Product Change Notification: PCN-23-180454

PCN Date: 07-AUG-23

General Product Description:
HD20 - COVER KIT (9 POS.) HD20 - KAPPENKIT (9 POL.) WITH CABLE CLAMP / MIT KABELSCHELLE

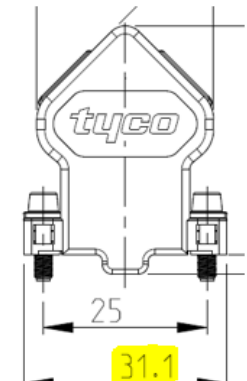
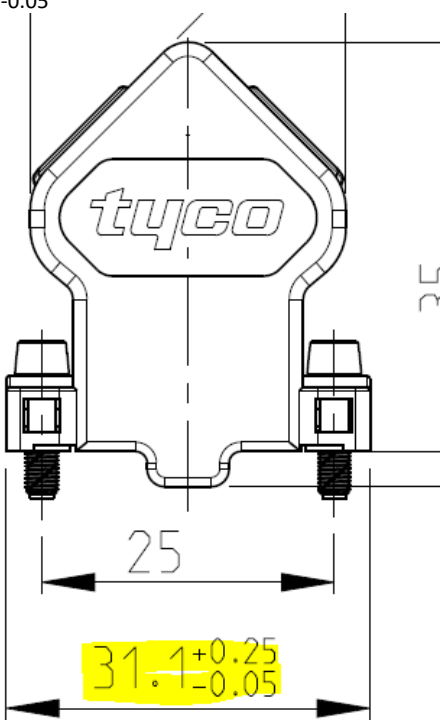
1534805 C drawing, Existing Outer width dimension is 31.1 +0.15/-0.15	1534805 C drawing, Outer width dimension will be modified as 31.1 +0.25/-0.05								
 <p>TOLERANCES UNLESS OTHERWISE SPECIFIED: ALLGEMEINTOLERANZEN</p>

since this tool is been running for long now and as days pass, given the die casting process, it is a challenge to meet the close tolerance in day to day manufacturing and hence based on the supplies till date, we have arrived that at the revised tolerance that can be maintained going forward

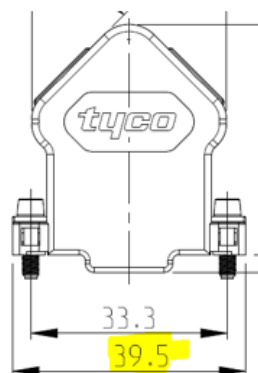
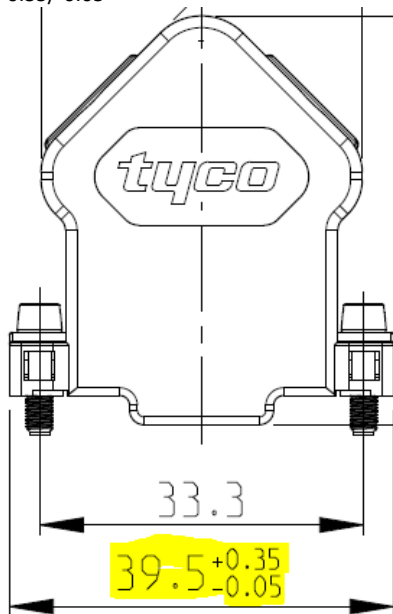
1534807 C drawing, Existing Outer width dimension is 39.5 +0.15/-0.15

1534807 C drawing, Outer width dimension will be modified as 39.5 +0.35/-0.05
